Addendum #1 to SJPC-22-52 (Pier 1 Sinkhole Repairs): November 30, 2022

SJPC 22-52

SINKHOLE REPAIRS

AT PIER 1 BROADWAY TERMINAL

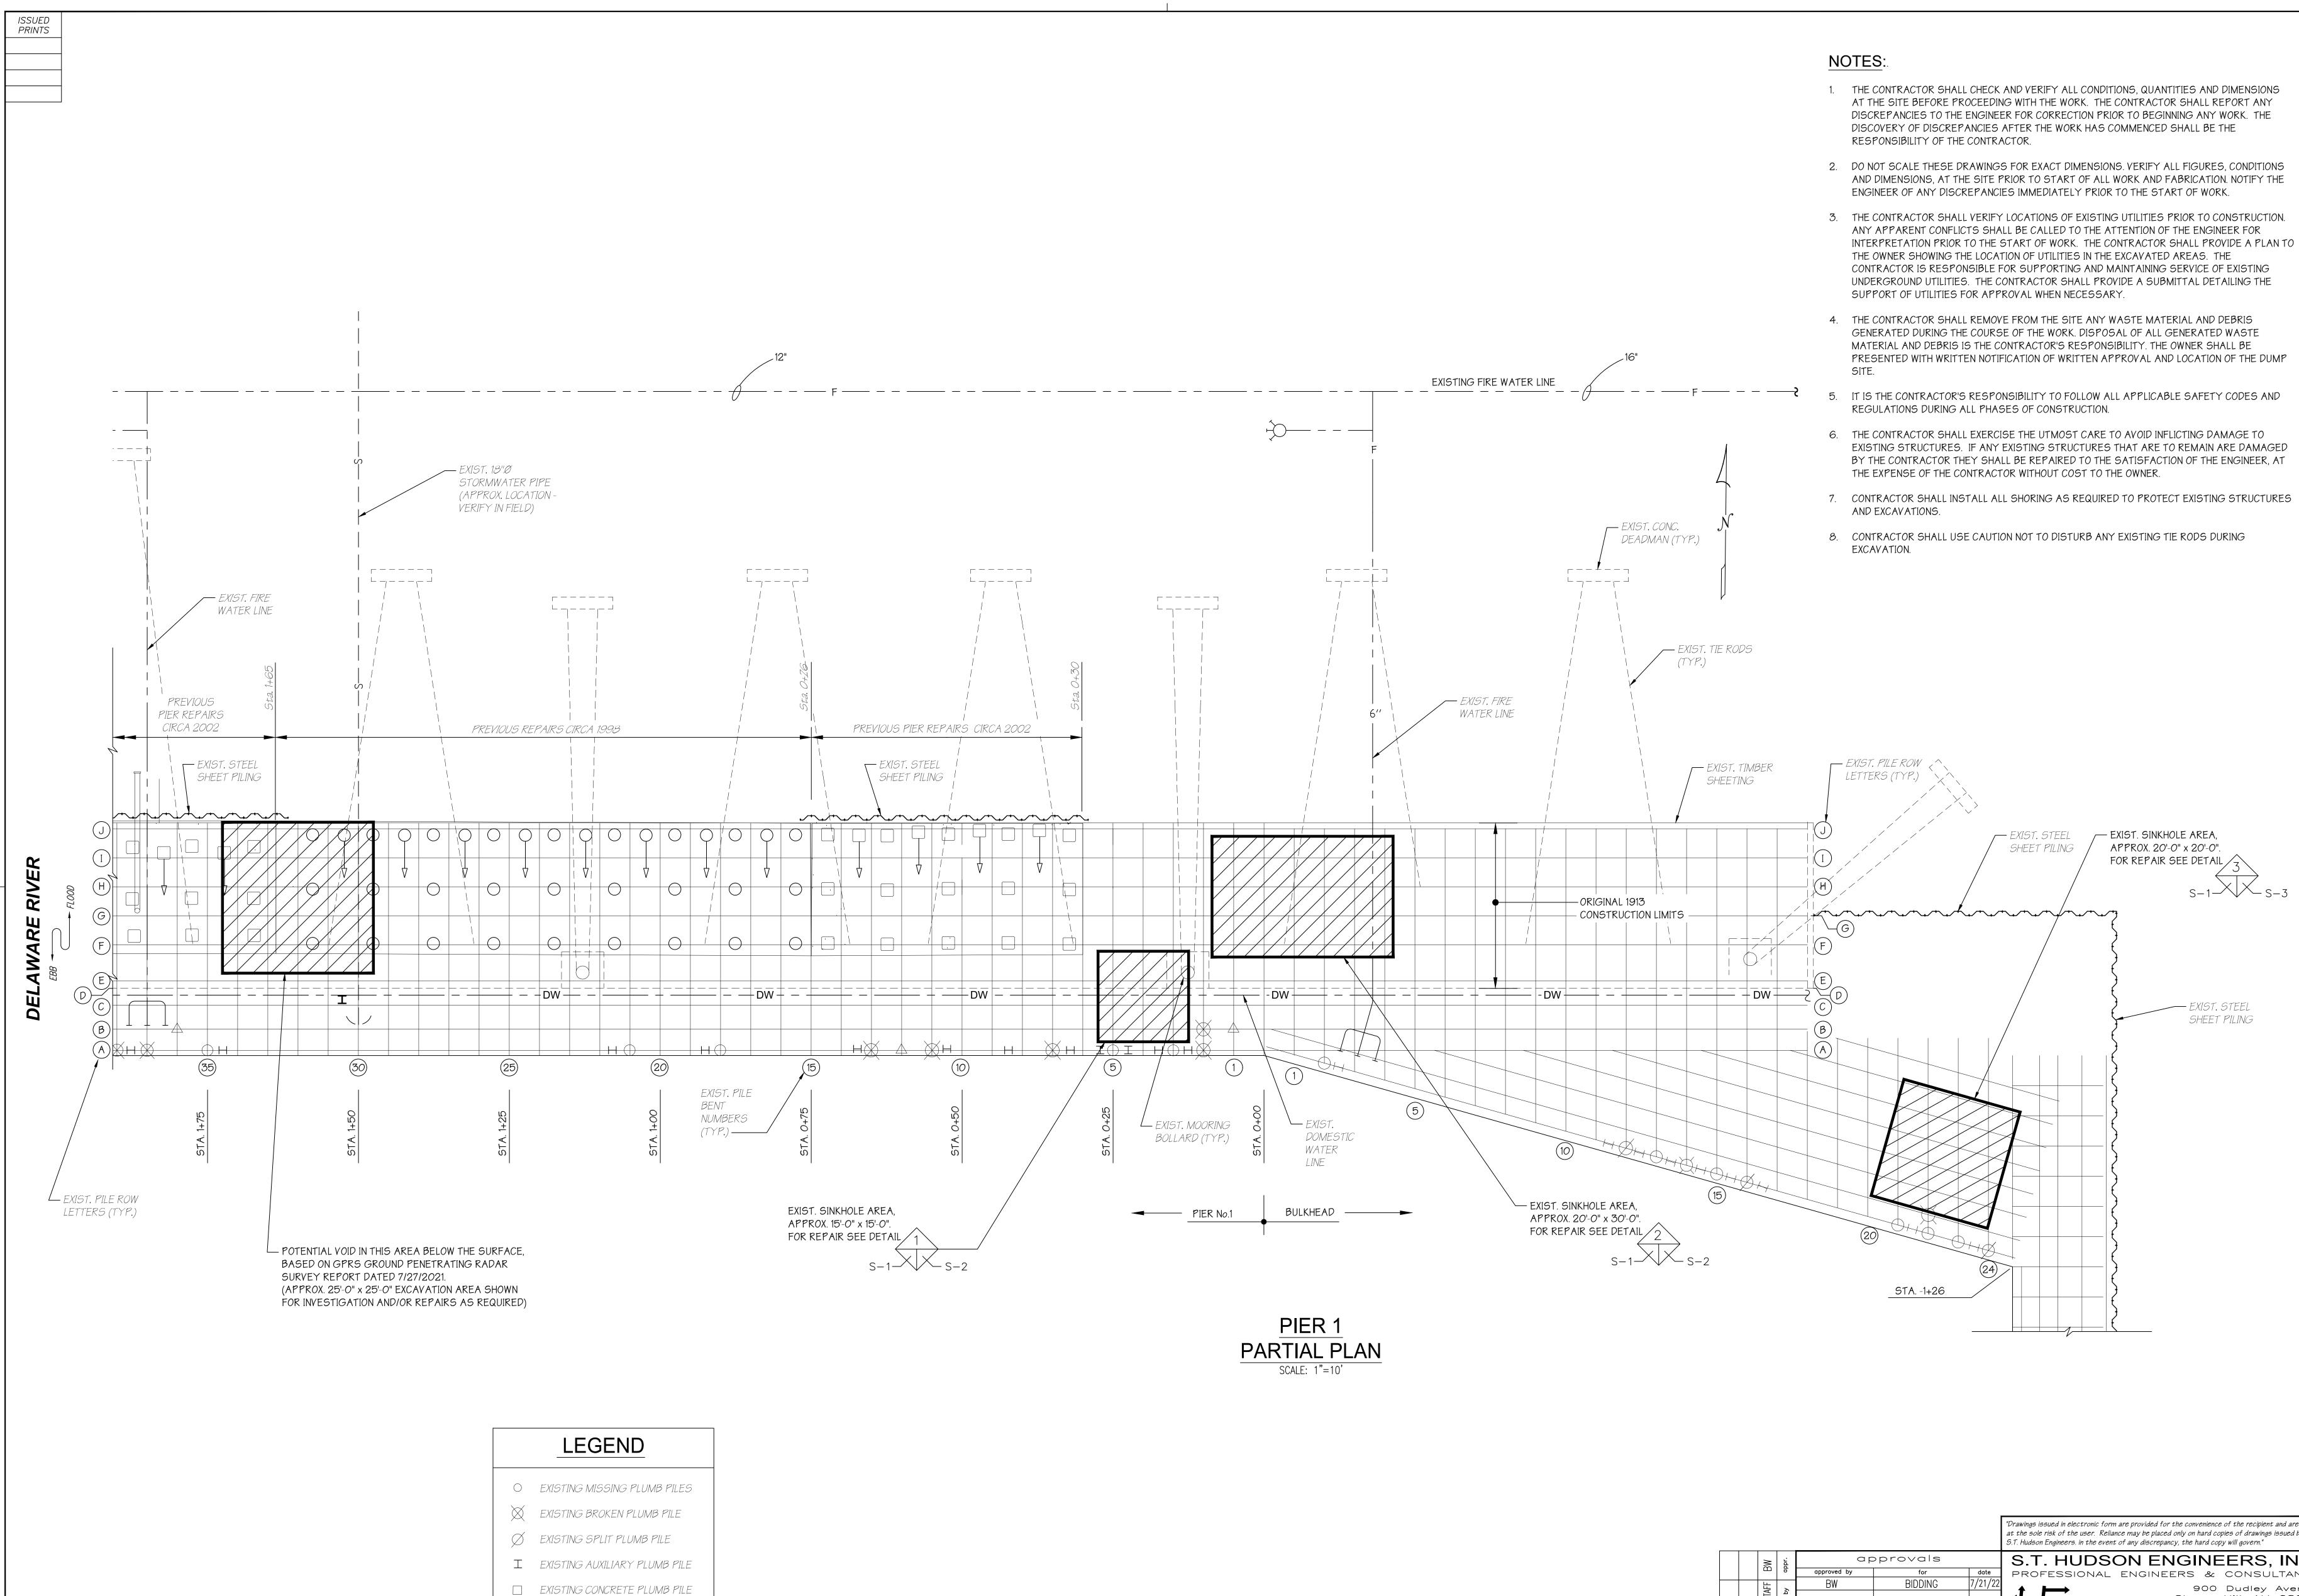
Please see the attached, revised bid form and drawing.
